Inspection Report

Minerals Regulatory Program
Date of Report: December 3, 2007

Mine Name: Bonanza
Operator Name: American Gilsonite

Permit number: M0470010
Inspection Date: November 27,
2007
Time: 10:00 AM to about 12:30
PM

Photo 1. B-40.

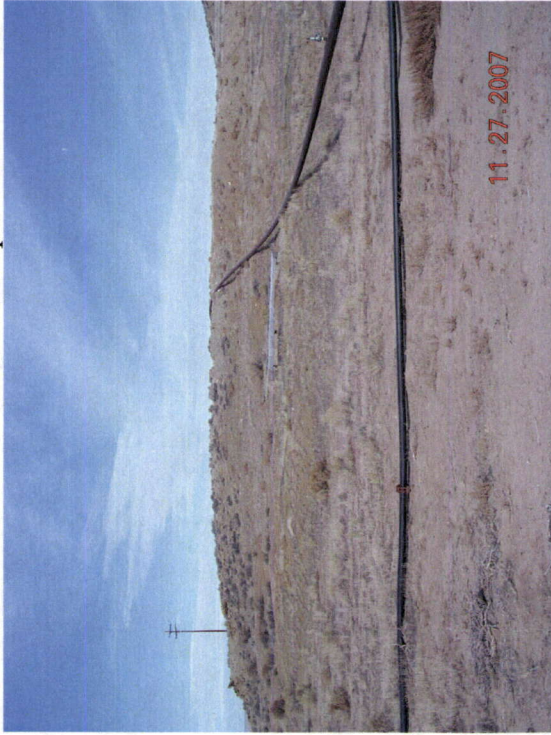
Site B-40 (Photo 1) has a moderate amount of greasewood, big sage, and rabbitbrush, but most of the vegetation is cheatgrass and halogeton (now dead). I did not measure cover, but it appeared to be similar to that found in some of the adjacent undisturbed areas.

Photo 5. LE-10.

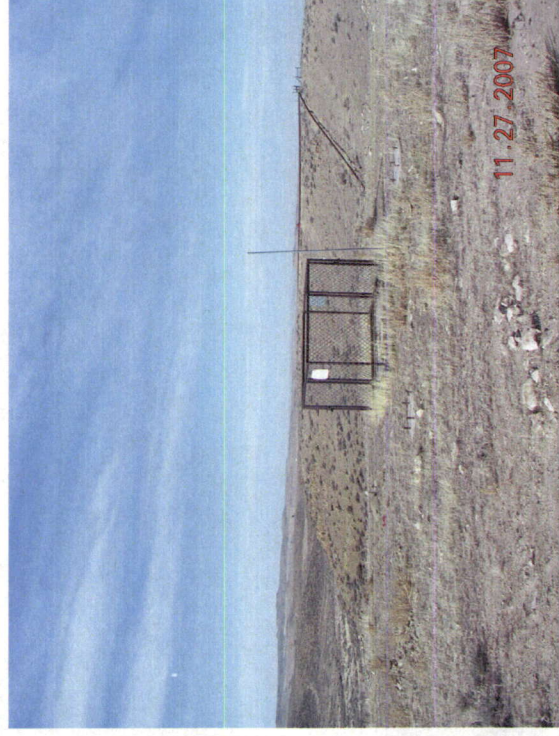
In a letter dated March 7, 2007, the Division stated that revegetation still needs to be accomplished at sites B-40, WH-12, LE-10, LE-16, LE-19, and LE-20. The operator responded that he felt these sites had adequate vegetation. LE-10 is typical of these sites (except B-40) and is shown in Photo 5.

Vegetation at the other sites consists primarily of cheatgrass and halogeton with a few scattered plants of snakeweed, rabbitbrush, and big sage.

Vegetation cover at sites WH-12, LE-10, LE-16, LE-19, and LE-20 is probably about the same as in nearby undisturbed areas, but the problem is that there is little perennial cover meeting a wildlife habitat or grazing postmining land use. The Division normally uses cover values from non-weedy vegetation to compare reclaimed and undisturbed areas.

Photo 6. A drainage channel that carries water from a mine water discharge point. Note the salt crusts on the banks.

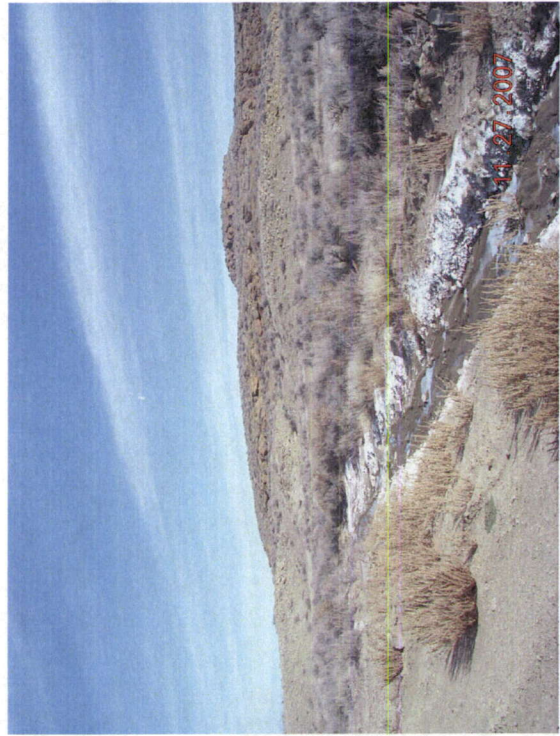
We crossed a drainage that had a lot of salt crust on the banks (Photo 6), and this drainage apparently carries water from a mine water discharge. Mr. Jackson said the TDS limit is 3500 ppm, and the two lab reports in the Division's file show TDS values of 2650 and 2800 ppm.
